**TOWN OF NEWBURGH  
PLANNING BOARD  
TECHNICAL REVIEW COMMENTS**

**PROJECT: MILLER ENVIRONMENTAL GROUP-SITE PLAN/LOT LINE CHANGE**  
**PROJECT NO.: 19-27**  
**PROJECT LOCATION: SECTION 98, BLOCK 1, LOT 27.2**  
**REVIEW DATE: 8 JULY 2021**  
**MEETING DATE: 15 JULY 2021**  
**PROJECT REPRESENTATIVE: TALCOTT ENGINEERING- CHARLIE BROWN, P.E.**

Re: Resubmission letter  
Town Project No. 2019-27  
Site Plan and Lot Line for Miller Enviromental Group  
77 Stewart Avenue  
SBL: 98-1-8.223, 20.-1, 18  
IB Zone  
Job No. 19036-MEV

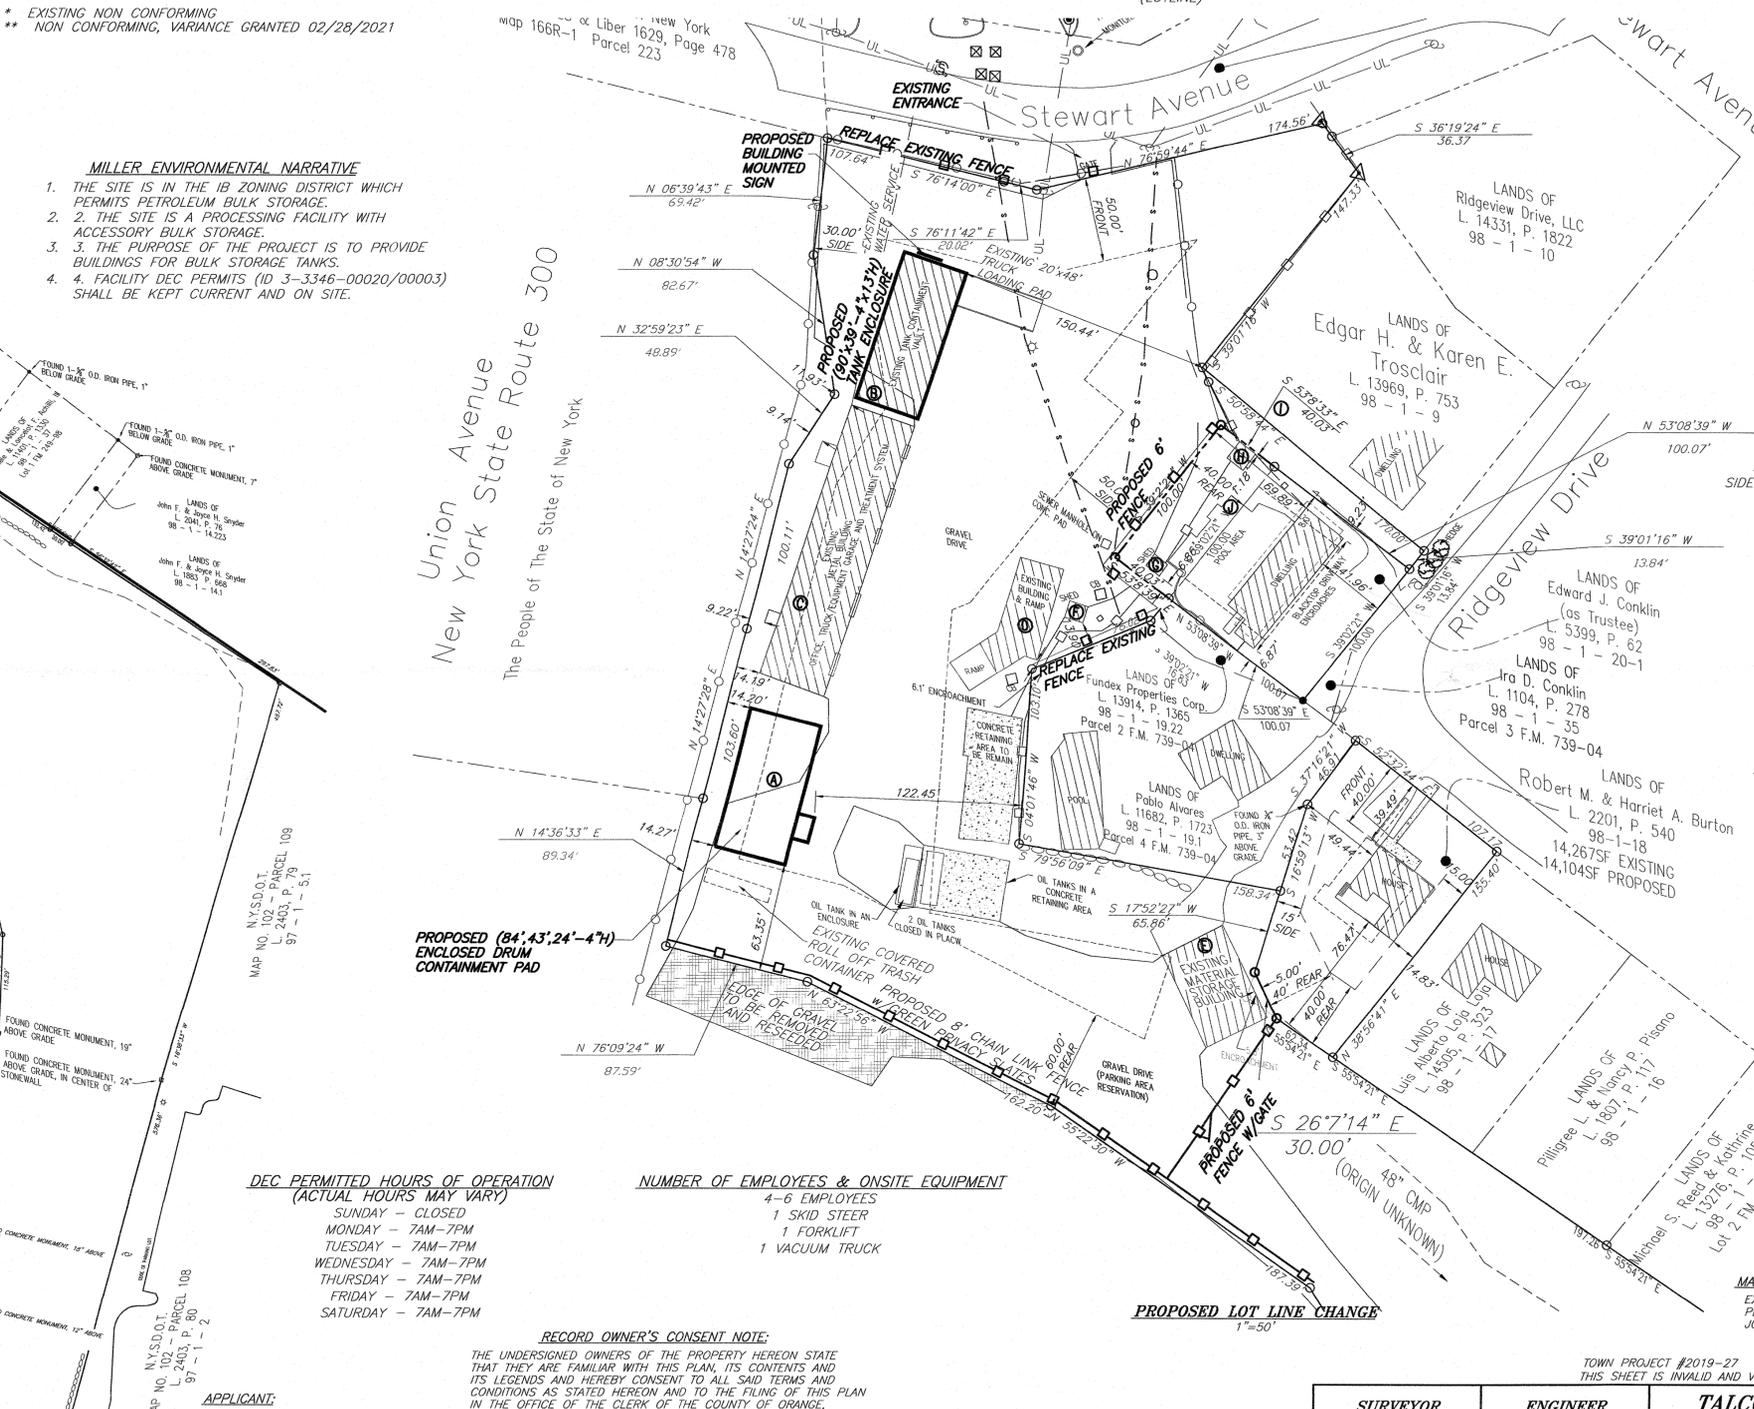
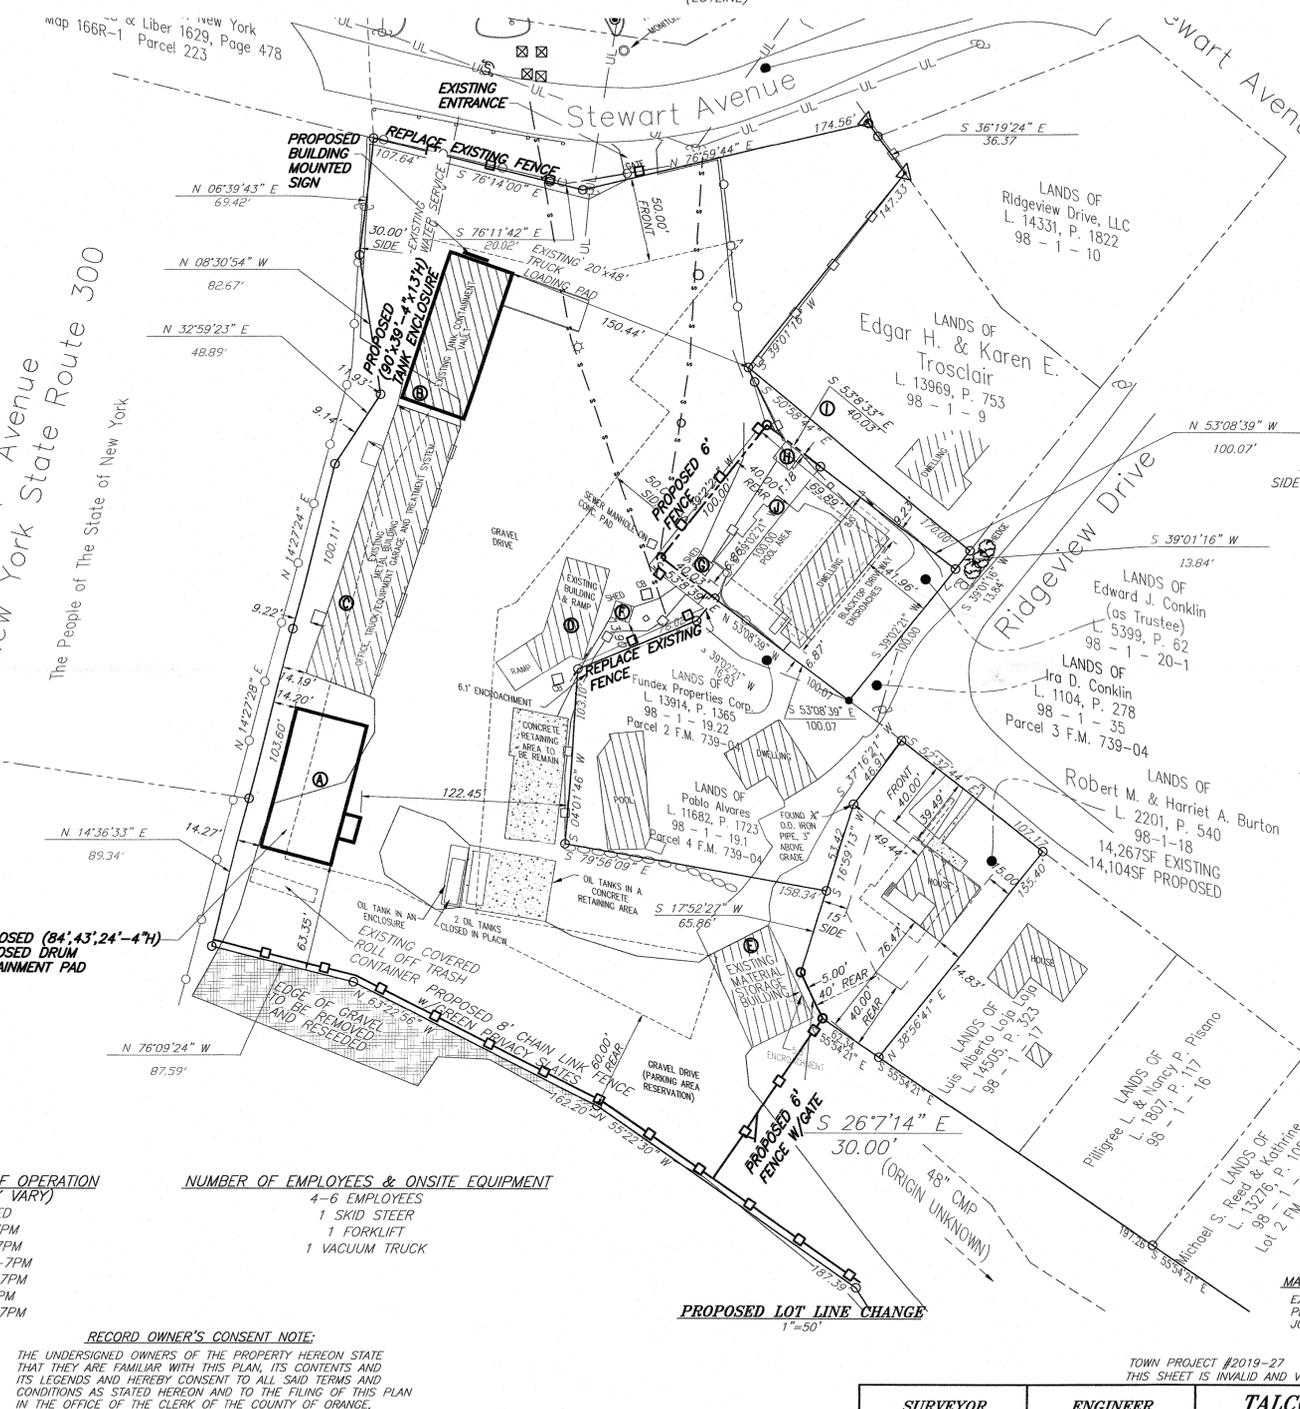
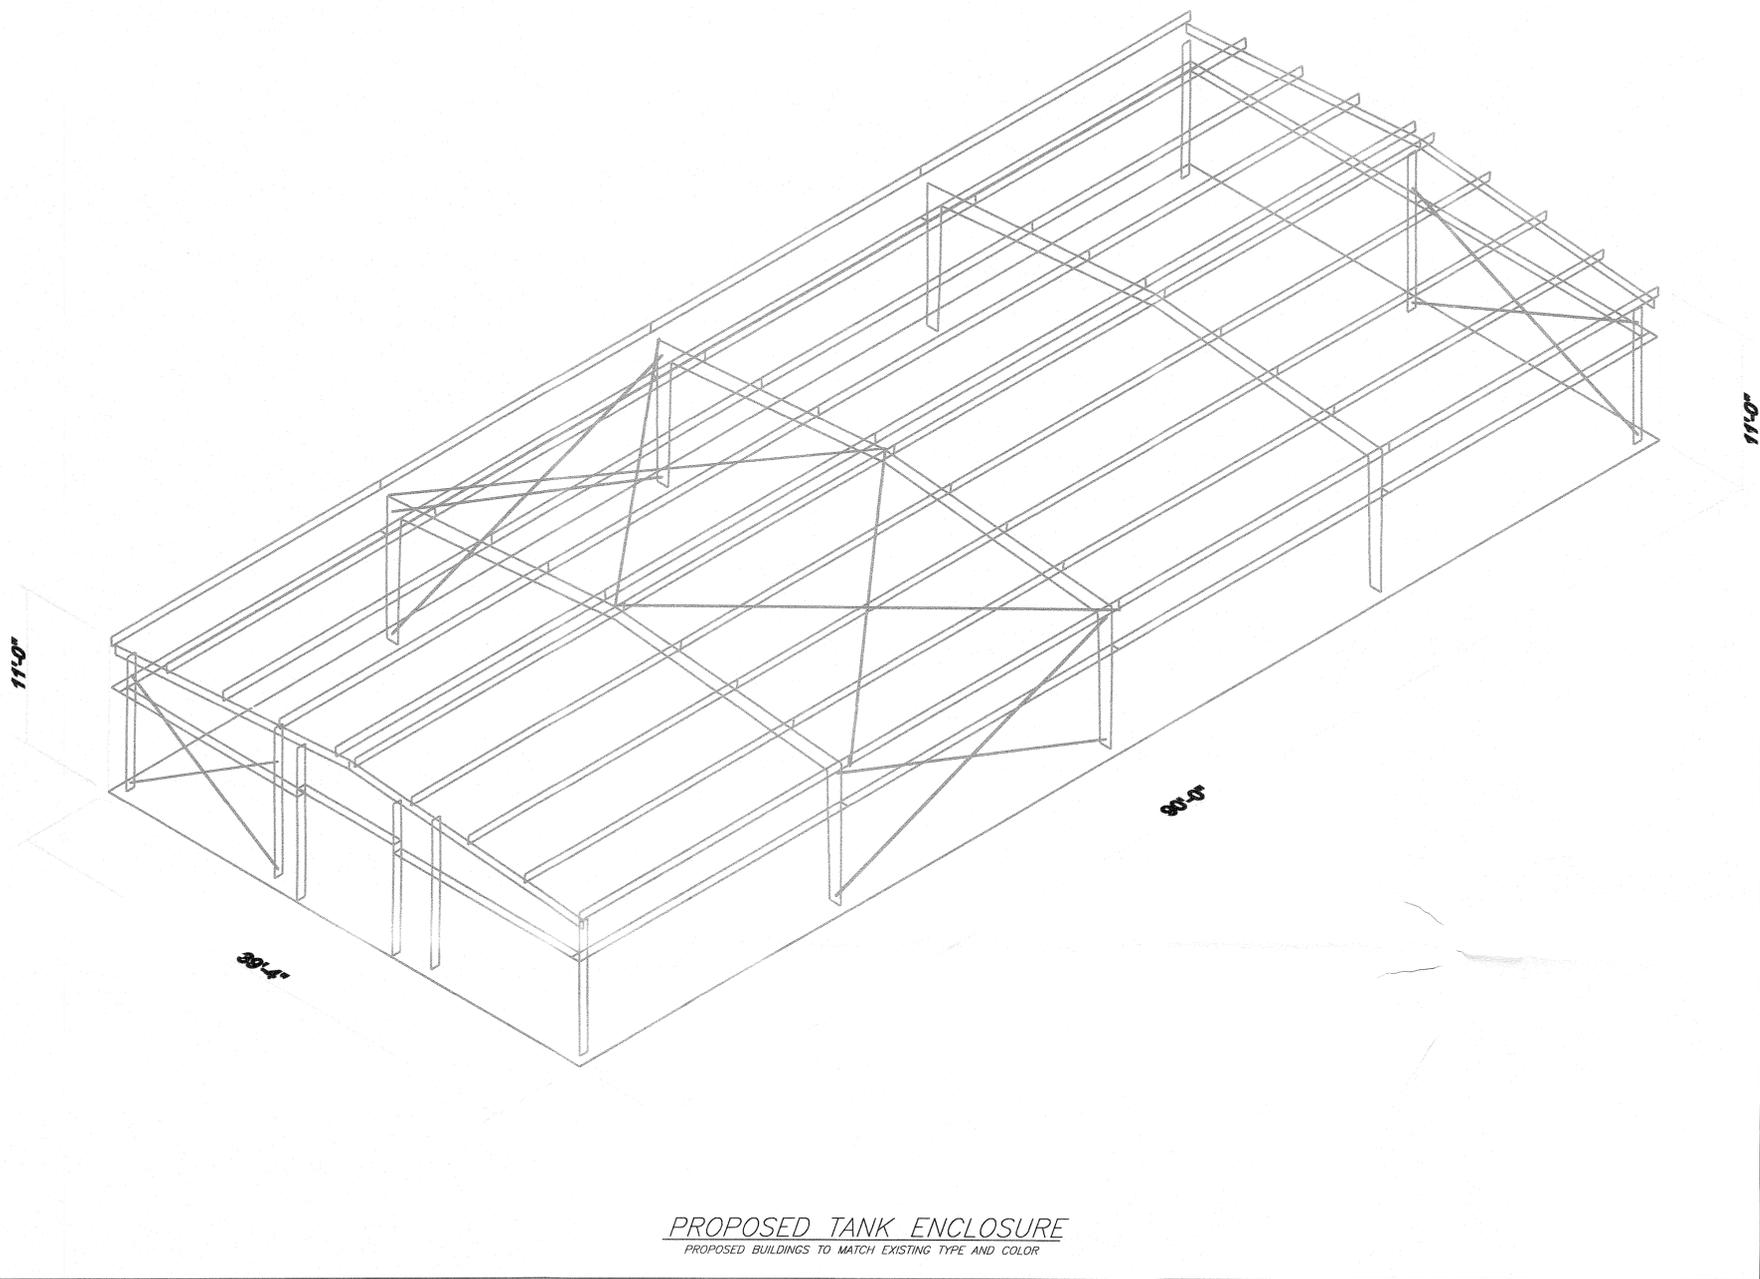
1. The ZBA has approved variances dates 29 February 2021.
2. The encroaching oil tank on the NYS Thruway property should be identified to be removed prior to final approval.

3. A discrepancy on the plan date for the ZBA identifies 28 February 2021 while the Narrative Report identifies 29 February 2021. This should be clarified.

8. Highway Superintendent's comments regarding the location of the access drive should be received.
9. The applicant's have identified they are requesting a waiver for topography on the site plan.
10. 6-foot fences are proposed on the site, while 8-foot fences are shown in the detail.
11. This project must be submitted to the Orange County Planning Department due to its proximity to State Highway 300 and NYS Route 84.
12. ARB approval for the proposed structures is required.
13. A Public Hearing is required and can be scheduled after the Board considers the SEQRA review of the project.

14. Copies of all permits and approvals from outside agencies should be provided including but not limit to the NYSDEC and City of Newburgh.
15. The Bulk Table should be revised regarding side yard. One side yard is 30, both side yards is 80.

16. The south property line should be proposed to be fenced to eliminate the encroachment onto state property.
17. Provisions of Section 185-39 Petroleum Bulk Storage should be addressed in a project narrative and appropriate notes on the plans.

- 1) Setbacks updated per ZBA approval 02/29/2021.
- 2) Oil tank shall be removed. Lot line change with lot 18 as proposed removes encroachment.
- 3) Existing add proposed lighting added.

- 14) Information on DEC discharge attached.
- 15) Bulk table revised.
- 16) Fence is proposed along southern property line.
- 17) The attached narrative has been added to plans.
